AMENDMENTS TO THE DRAWINGS:

REMARKS

In the Office Action¹, the Examiner objected to the drawings; objected to the specification; objected to claims 1-6 because of informalities; rejected claims 1, 4, and 6 under 35 U.S.C. § 112, second paragraph, as being indefinite; rejected claims 1-6 under 35 U.S.C. § 102(b) as being anticipated by Sano et al. (U.S. Patent Application Publication No. 2003/0002742, hereafter "Sano").

FIG. 1

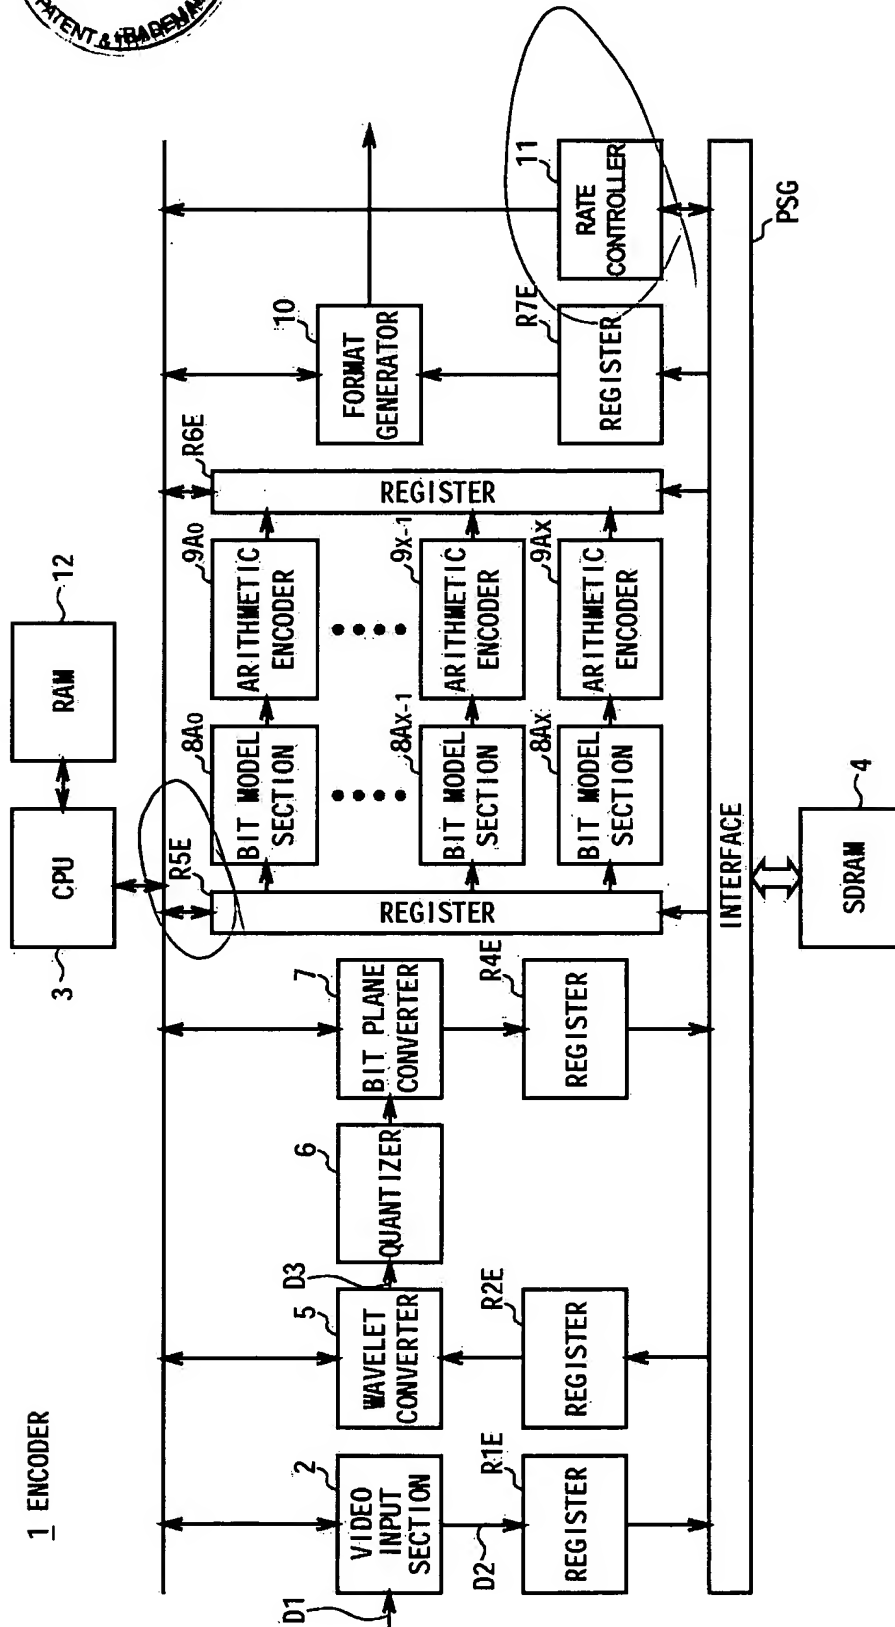
Regarding the objection to the drawings, Applicant has amended Figures 1, 6, 7, and 13. Specifically, Applicant has amended Figure 1 to replace non-English characters in box 11 by --RATE CONTROLLER--, and add reference characters --R5E--; amended Figure 6 to replace "RT0" by --RT1--; amended Figure 7 to replace "BitTmp" by --BitsTmp--; and amended Figure 13 to replace "SP27" by --SP45--, and match reference characters "SP53" and "SP54" with the written description. Applicant submits herewith four (4) sheets of replacement drawings, labeled "Replacement Sheet 1/4," "Replacement Sheet 2/4," "Replacement Sheet 3/4," and "Replacement Sheet 4/4," and four (4) sheets of annotated replacement drawings, marking changes in red. Accordingly, Applicant respectfully requests withdrawal of the objection to the drawings.
